**Subject: Beaver Valley Power Station, Unit No. 1
BV-1 Docket No. 50-334, License No. DPR-66
Reply to Request for Additional Information Regarding
Order EA-03-009 Relaxation Request**

**Responses to NRC Questions
Regarding Beaver Valley Power Station (BVPS) Unit 1
Order EA-03-009 Relaxation Request**

Figure 6
Hoop Stress Vs Distance from Bottom of Weld
40.0° CRDM Penetration Nozzle –Downhill

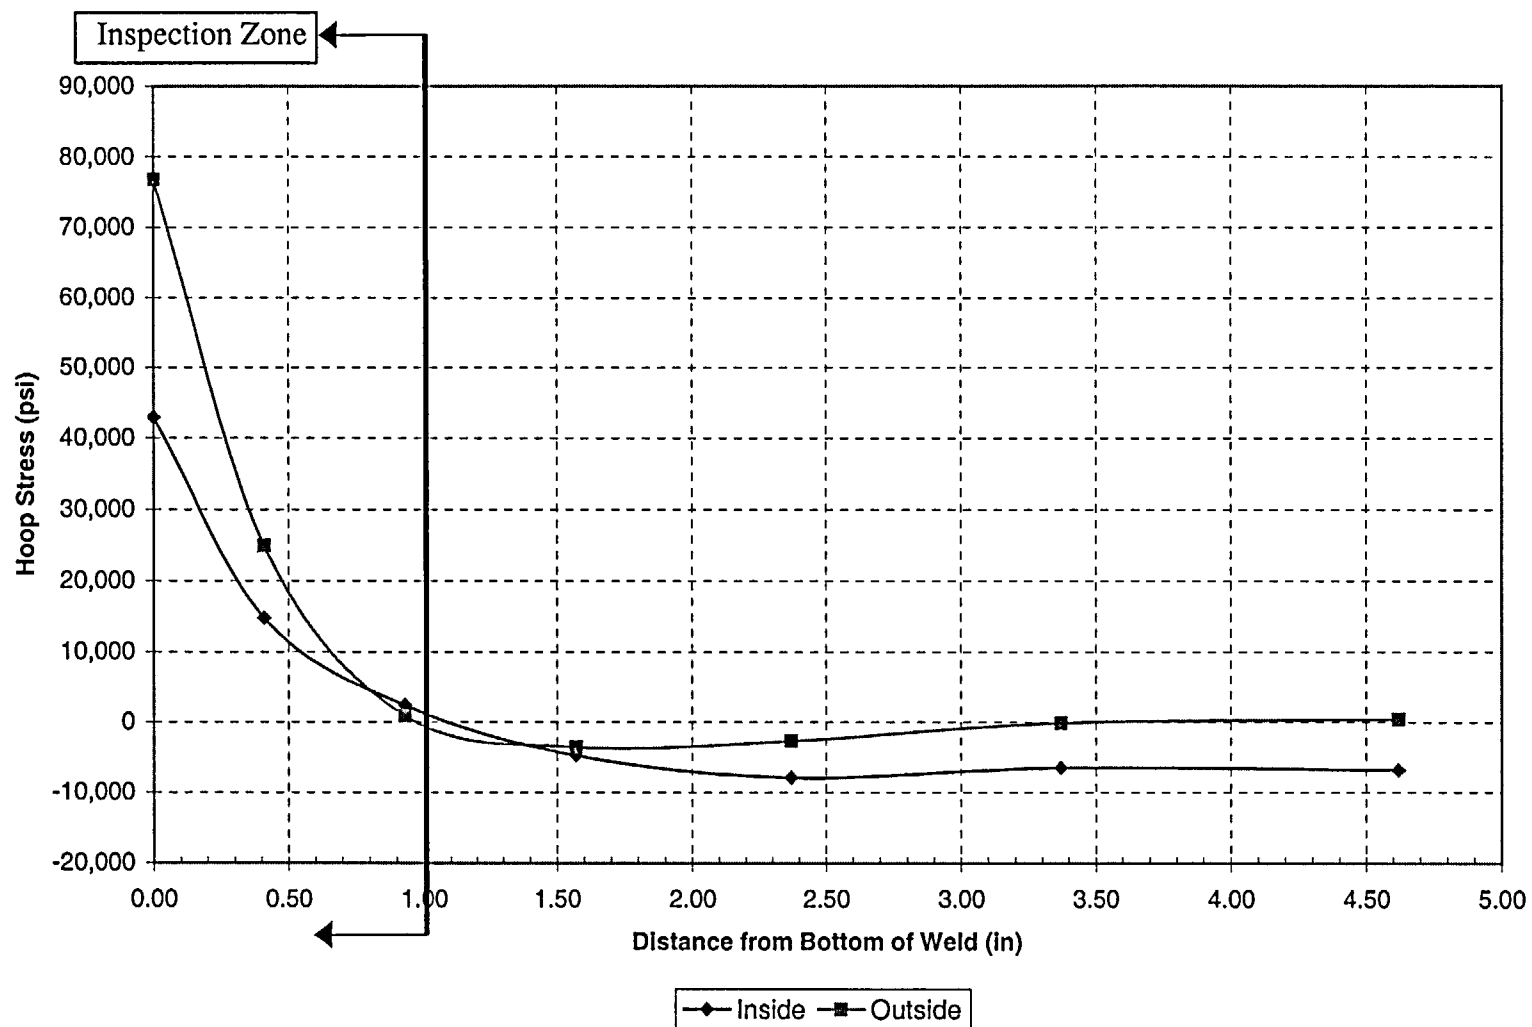
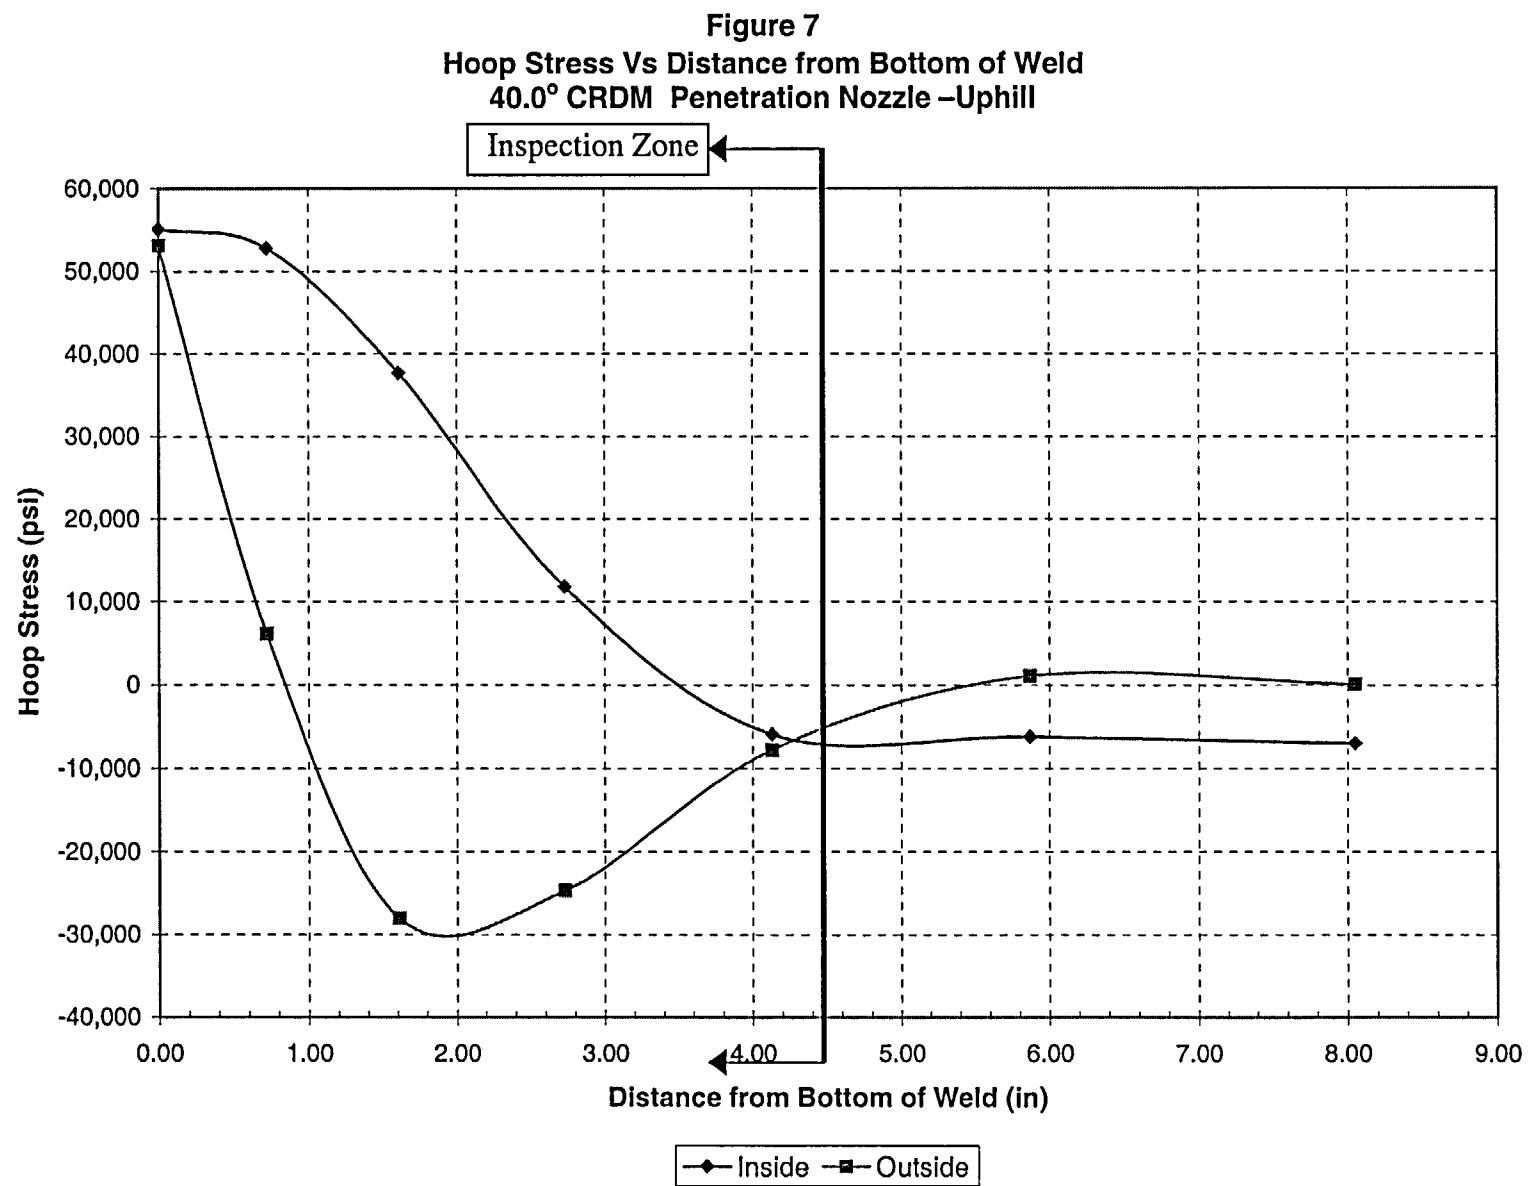
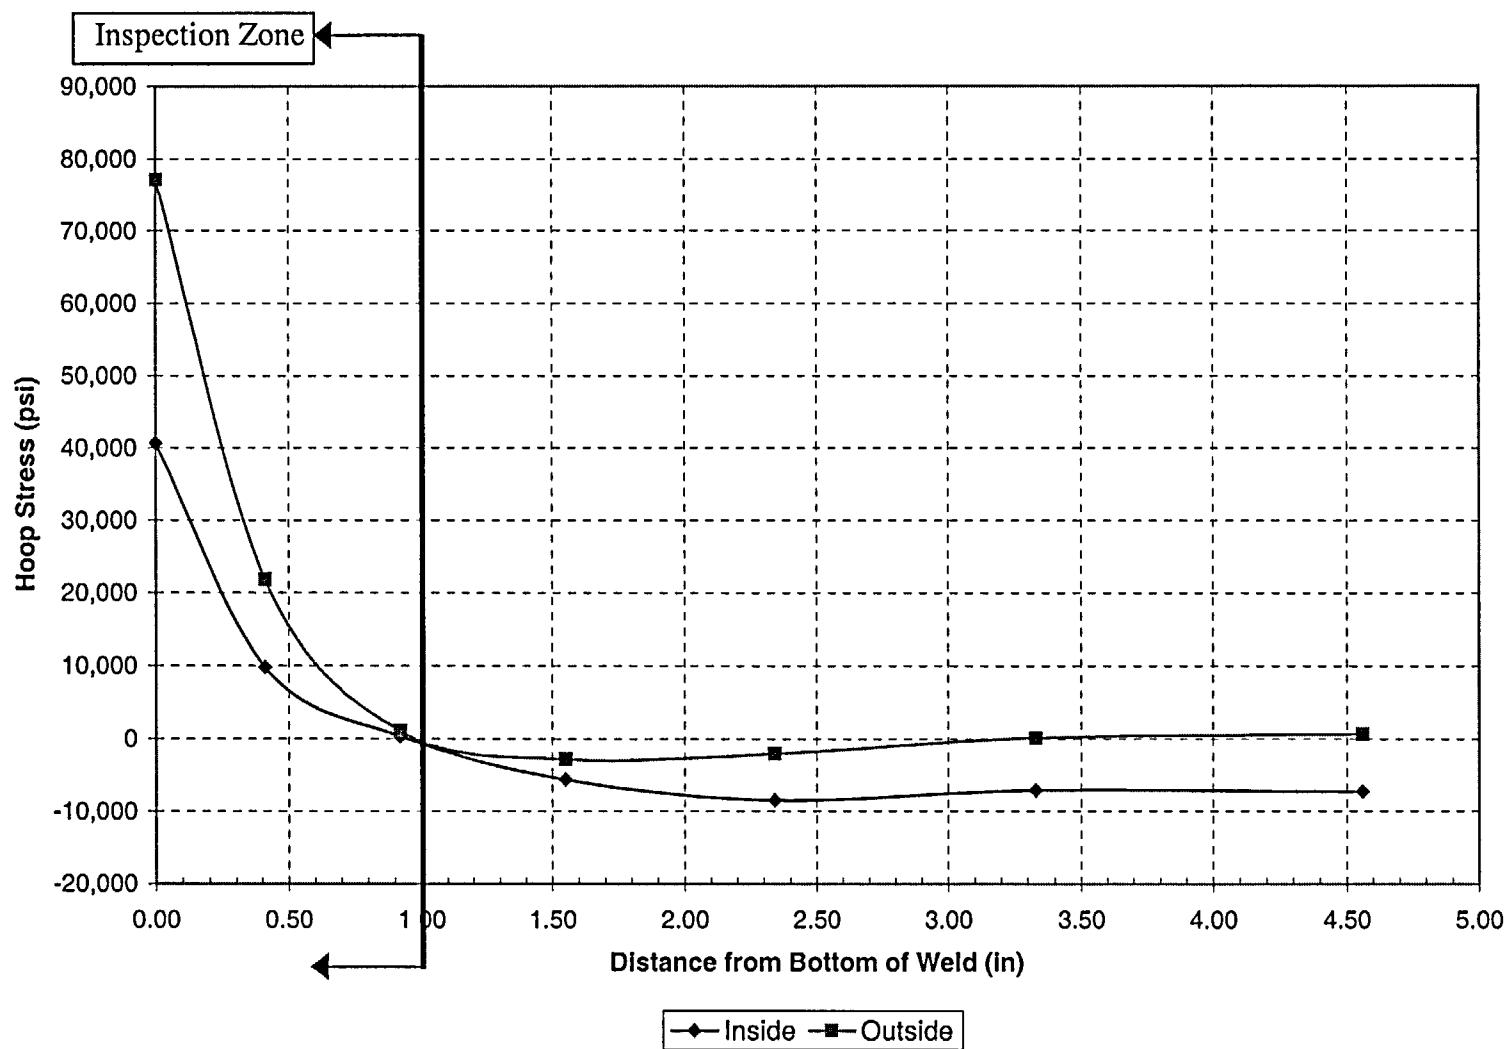
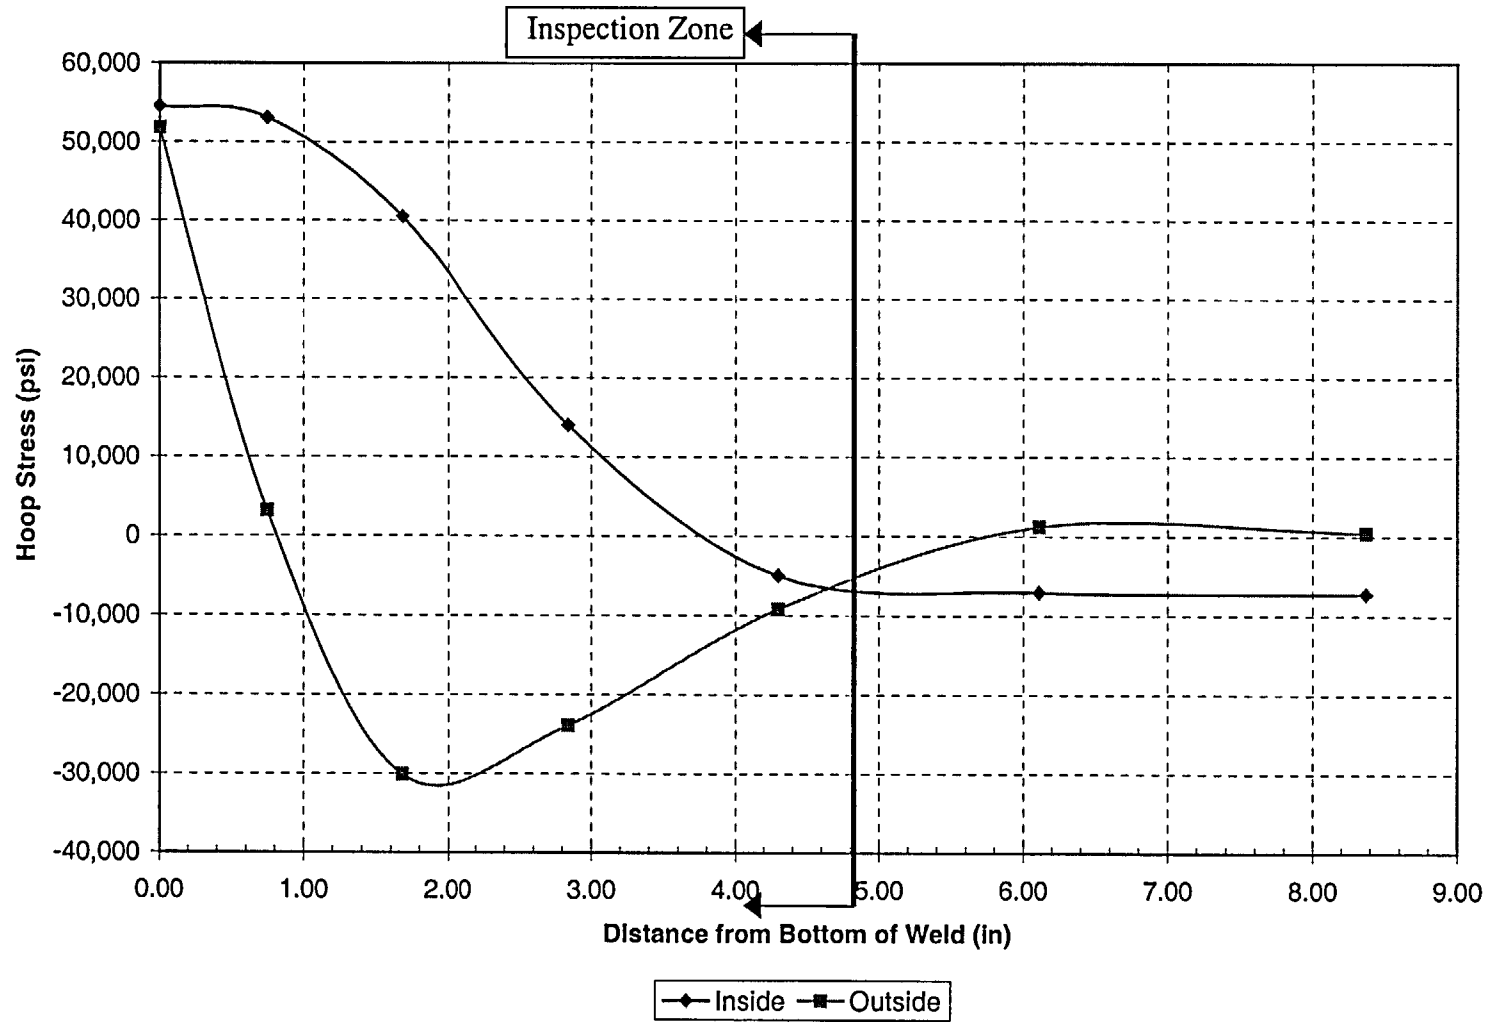
Question 2. *The request states that, "The magnitude of the stresses in these portions of the nozzles is low based on information from other plants of similar design and construction." Discuss how this information is applicable to your plant. Provide tabular listings of the maximum stress in the cross-section from the top of the J-groove weld region to the area covered by your relaxation request.*

The hoop stress distributions as a function of distance from the bottom of the weld for a range of penetration nozzles located at the center of the vessel head to the outermost nozzles are provided in Figures 1 to 9. The expected "inspection zone" is also identified in each figure. This information is provided in graphical versus tabular format. As shown in Figures 1 to 9, the magnitude of the stresses in the unexamined portion of the nozzles is low. See response to Question 3 for further information.

Figure 10
Through-Wall Axial Flaws Located in the 28.6 Degree Row of
Penetrations, Uphill Side - Crack Growth Predictions

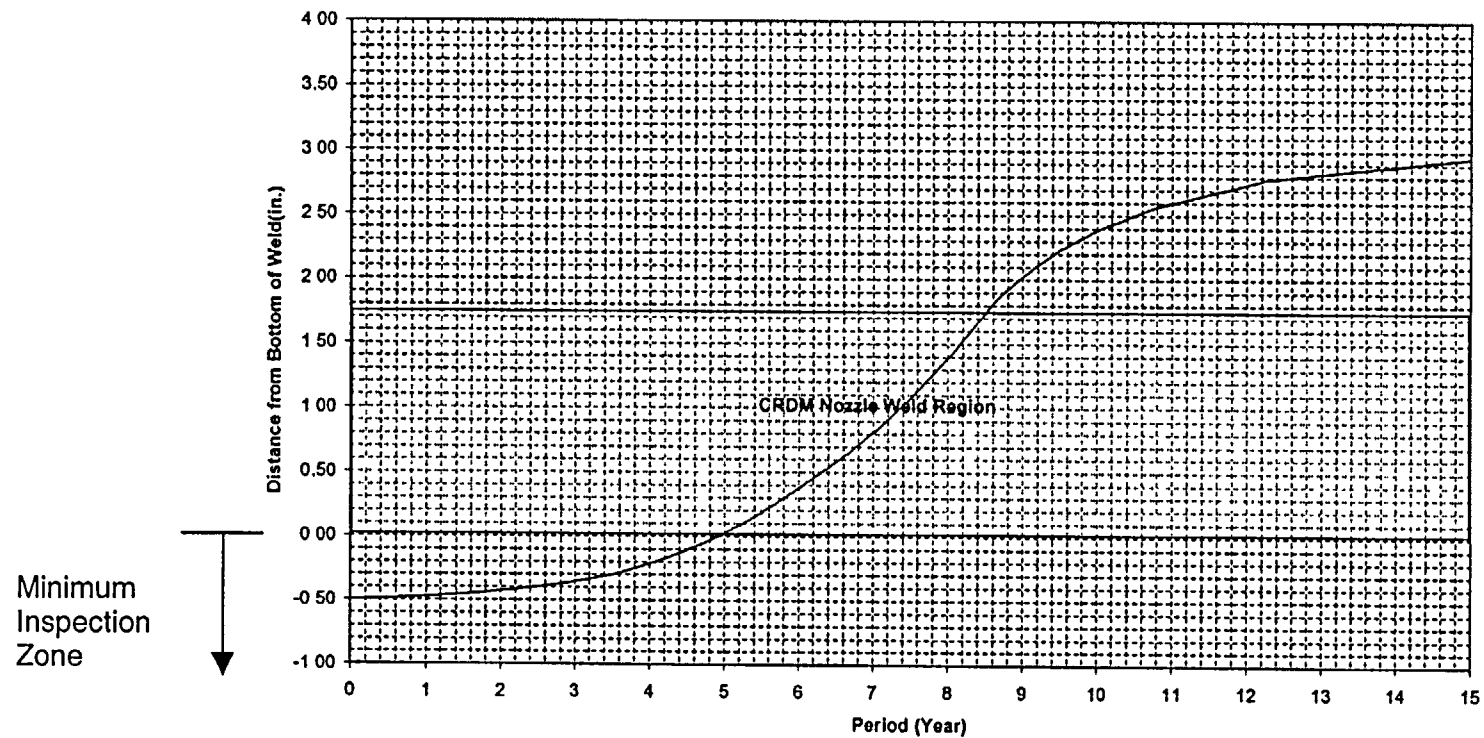
Question 3. The request also states that, "there are no concerns with the structural integrity of the vessel head penetration nozzles from the unexamined bottom portions of the nozzles addressed in this request." Provide the technical basis, such as an analysis or an evaluation to show that cracks initiated from the unexamined area will not propagate into the pressure boundary and exceed the Code allowable crack sizes within one operating cycle, based on a conservative crack growth rate from the industry operating experience.

The examination coverage from the bottom of the J-groove weld towards the bottom of the nozzle is expected to be a minimum of 1.0 inch. To determine the significance of such an axial flaw located more than 1.0 inch below the weld, a flaw tolerance approach is used. The flaw evaluation results obtained from a plant of similar design and construction as BVPS Unit 1 were used. See response to Question 2. The evaluation postulated an axial flaw in the unexamined area below the weld. The evaluations performed are based on a methodology consistent with the recently approved Section XI flaw evaluation approach, with a Primary Water Stress Corrosion Cracking (PWSCC) crack growth rate that is consistent with the MRP-55 Rev. 1 report. A through wall axial flaw was postulated in the nozzle material growing upwards towards the bottom of the weld. Since the stresses for the portion of the nozzle more than 1.0" below the weld are too low to propagate an axial flaw, the flaw evaluations start at 0.5" below the weld and the time to propagate the flaw in the nozzle to the bottom of the weld (start of the pressure boundary portion of the nozzle material or toe of the J-groove weld) was determined. Assuming a through wall flaw below the weld, with the flaw end located at 0.5" below the weld (which is in the area of complete examination coverage), an axial flaw would take approximately 5 years of operation to grow to the point of contact with the weld, and even longer for it to grow from the bottom of the weld upwards through the pressure boundary. This time period is significantly greater than the current inspection frequency of every refueling cycle (approximately 18 months for BVPS Unit 1) identified in NRC Order EA-03-009.

Figure 10 provides a graphical presentation of the above flaw evaluation discussion for the limiting penetration location. Based on the crack growth results shown in Figure 10, there are no concerns with the structural integrity of the reactor vessel head penetration nozzles that could be caused by axial cracking in the unexamined non-pressure boundary portion of the nozzle material for a period of approximately 5 years of operation.
